Docket Item # 19-C
DEVELOPMENT SPECIAL USE PERMIT #2003-0013
West Glebe Road Townhouses

Planning Commission Meeting
October 7, 2003

ISSUE: Consideration of a request for a development special use permit, with site plan, for construction of twenty-four townhomes in a cluster development plan with site plan modifications.

Original proposed site plan

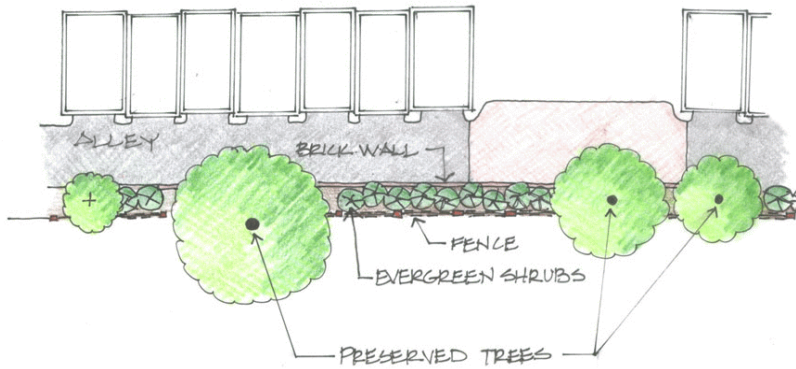
The original cluster development layout included townhouse units grouped into four buildings, with the curb cuts at each end of the development row, and the common open space divided into three areas between the four buildings plus two areas at each end of the site. While this arrangement was logical and orderly, it did not work to consolidate the open space into the largest possible area, so that they would be as attractive and usable as possible. Working with staff, the developer made several changes to create what staff and the applicant believe is a better open space arrangement.

First, the applicant revised its plans to reduce the number of units from 28 to 24, thus allowing more of the site to be green. In addition, by adjusting building widths and the spacing between the groups of units, the applicant has been able to create a large open space area in the center of the development, which is 76 x 43 feet or 3,268 sq. ft in area, and which will be planted and contain benches and walkways. At the two points where the driveway goes between the townhouses to the rear of the site, the applicant has included open space areas that are 62 and 64 feet wide. Although

Plan view of landscaped buffer

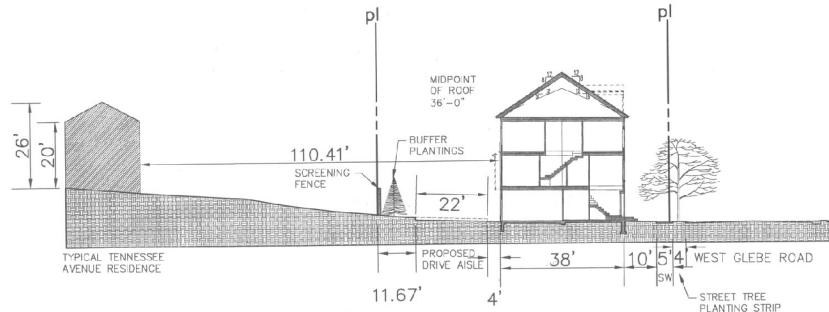
Working closely with the North Ridge Citizens Association and with the individual homeowners on Tennessee Avenue who abut the property at the rear, the applicant has designed a treatment for the southern boundary line that buffers the new development as much as possible from the existing residential homes and apartments behind the development site. The site is approximately 850 feet long at its southern border. The rear border is heavily wooded, and includes a number of mature trees. The grade between the sites changes; the land to the south rises above the level of the parking lot.

Attachment 1

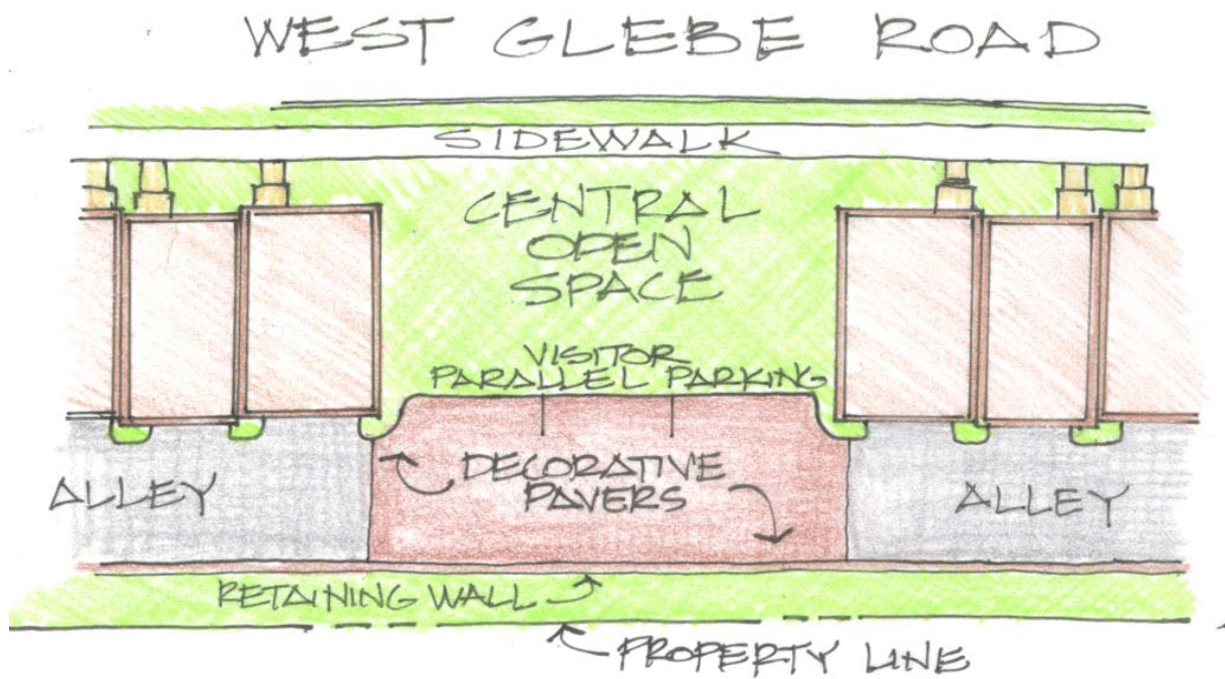
3. The three proposed parallel parking spaces adjacent to the central open space area shall be relocated to the eastern portion of the alley extension to the satisfaction of the Director of P&Z. Raised decorative brick pavers shall be designed to continue the appearance of the central open space area as generally depicted in *Attachment No. 1*. (P&Z)

Raised decorative brick paver area in alley adjacent to central open space
